CIVIL RIGHTS COMMISSION AGENDA:

Building an Accessible Oxford

DST 272 Honors City Audit

2025 ADA Assessment and Transition Plan

Load Times & Resource Usage

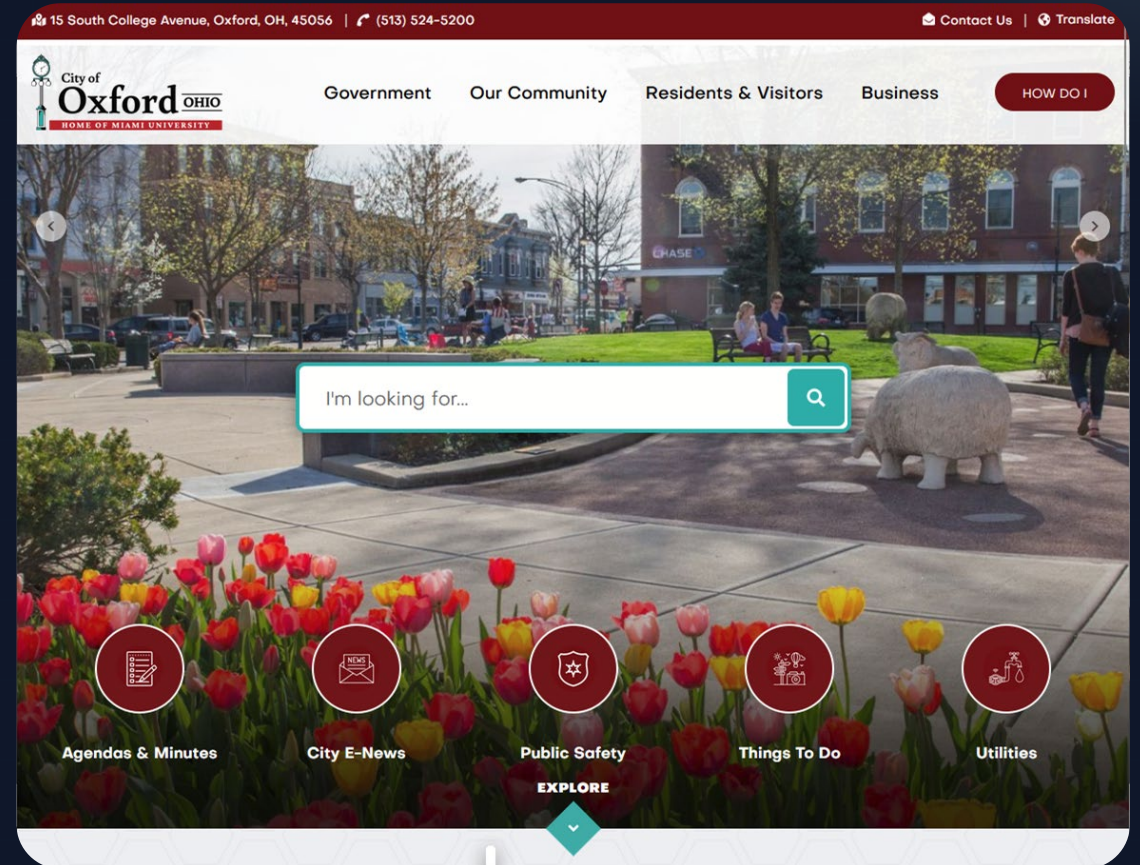
1. Some pages take well over 30 seconds to load at average consumer internet speeds
 - a. Recommended load time is 1second
 - b. 93% of total load time is due to large images
 - c. Severe usability impact
2. Uses $\frac{1}{8}$ of the total RAM in the average computer
3. Fully utilizes all available CPU for several seconds
 - a. Causes system-wide instability and crashes
4. Renders all information contained on the site fully inaccessible to everyone, not just disabled people

Uptown Parking Garage

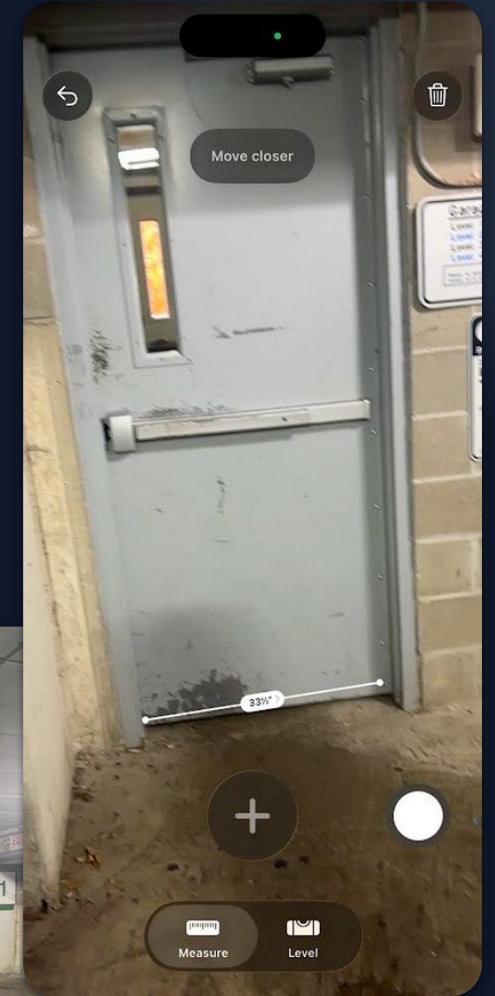
1. No ‘truly’ accessible entrances - the only open - air exit ramp is rather steep
2. No aisle next to accessible parking spots (aisle should be at least 5 ft wide).
3. Add some van accessible spaces (not the same as general accessible spaces since these are wider - at least 8 ft wide)
4. clearly mark accessible spots with high - contrast paint such as yellow to discourage misuse
5. Add some ‘Van Accessible’ signs

6. Unlevel ground with raised tripping hazard

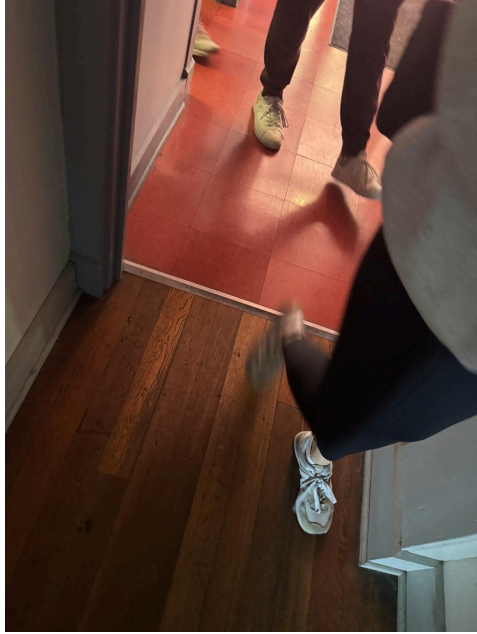
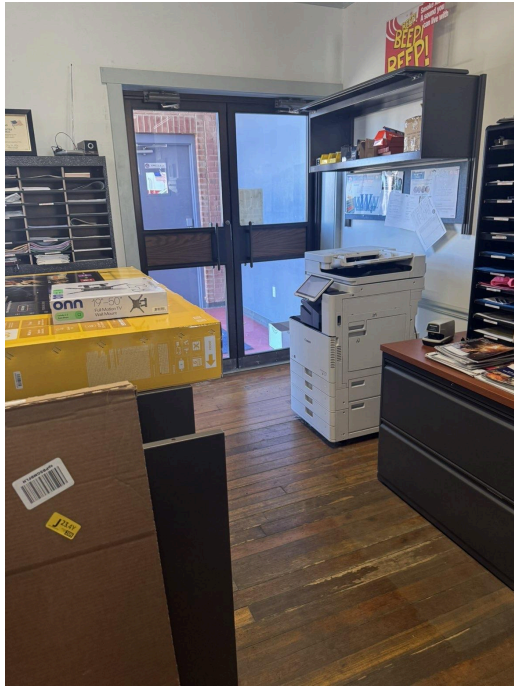
As we toured the station, we all immediately noticed a raised level in the ground that could be a serious tripping hazard. It was a transition from the red floor to the wooden floor. In

times of emergency, this could be a hazard for the firefighters rushing throughout the station. They are carrying heavy equipment and uniform so it wouldn't be easy to navigate this bump. This could also be a problem for someone in a wheelchair, non fire fighter workers and others walking around the station. It would require extreme strength to push someone in a wheel chair over that hump. Over time, this type of hazard not only increases the risk of preventable injuries but also contributes to an environment that is not fully inclusive or accessible for everyone who enters the station

We recommend hiring a professional to come and even the floor to ensure that there is a smooth transition from the red tile to the wood. This wouldn't cost much and would improve the accessibility and lower the risk of injury for not only firefighters but those visiting or working. It is important to not only address the larger issues, but also attend to small details to create an inclusive workplace and station.

Image 1.3 *Image shows the ramp, at the entrance with the attached parking lot, with a narrow ramp.

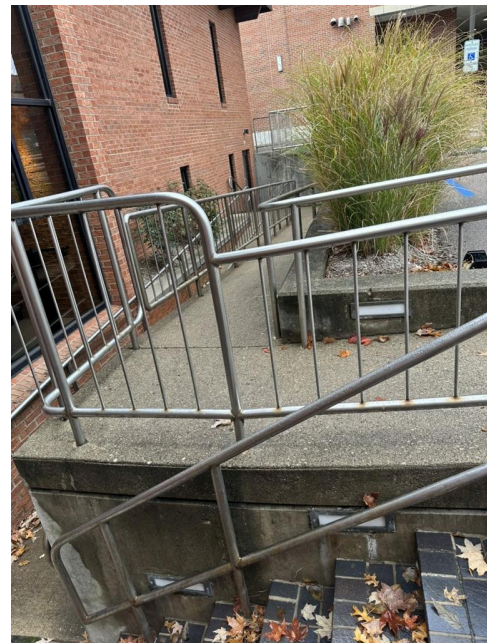
- Install electric door openers for bathroom entrances
- Redesign/widen wheelchair ramp
- Realign entry doors or remodel vestibule

Image 1.3 *Image shows the ramp, at the entrance with the attached parking lot, with a narrow ramp.

Image 1.4 *Image shows the ramp, at the entrance with the attached parking lot, with a ramp that has several narrow turns.

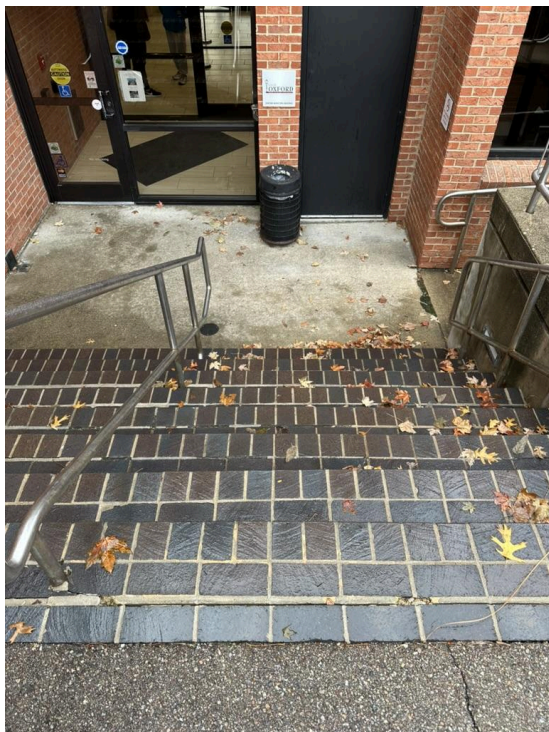
Image 1.4 *Image shows the ramp, at the entrance with the attached parking lot, with a ramp that has several narrow turns.

Image 2.1 *Image shows a small directory more difficult to read.

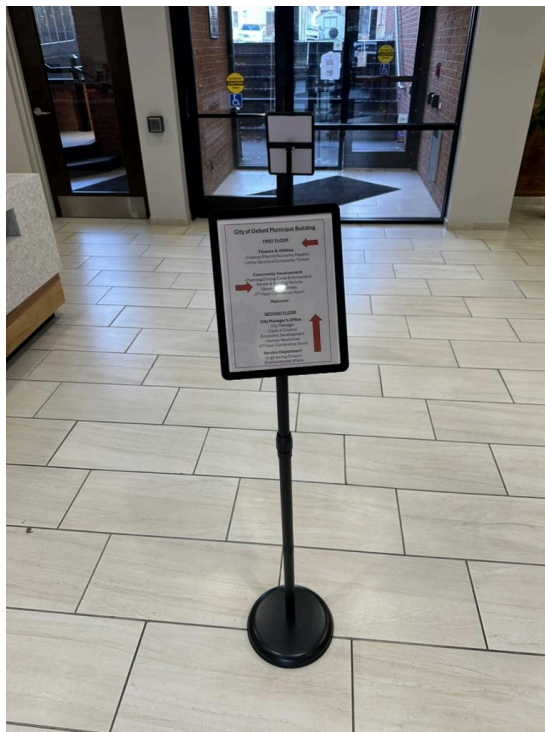
- Add an additional directory that is closer to the entrance on S. College Avenue. Currently there is one on a plastic stand however it is small and hard to read for people with visual impairments. All directories should also include braille for visual accessibility for all community members. **See image 2.1 and 2.2.**

Image 2.2 *Image shows directory without braille.

Image 2.3 *Sign says: WINDOW CLOSED PLEASE USE THE NEXT TWO WINDOWS THANK YOU!

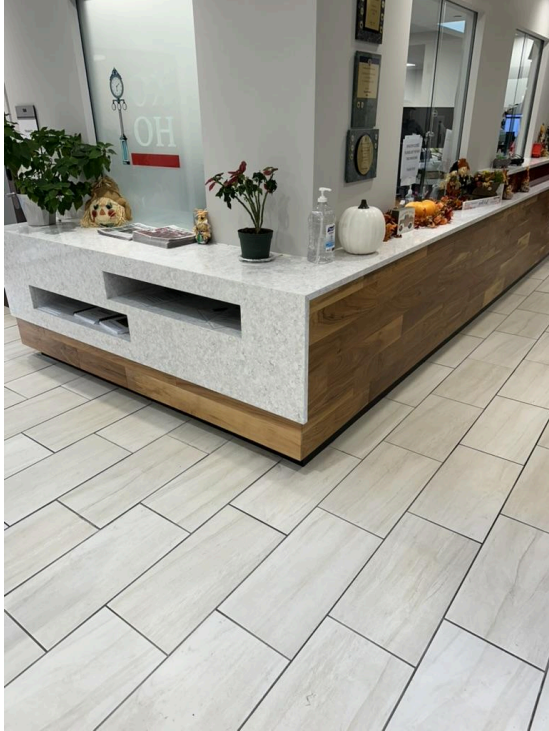
- Add a coat/backpack hook inside the accessible stall
- Keep the lower help desk window open at all times
- Improve accessible bathroom stall signage placement

Image 2.3 *Sign says: WINDOW
CLOSED PLEASE USE THE NEXT TWO
WINDOWS THANK YOU!
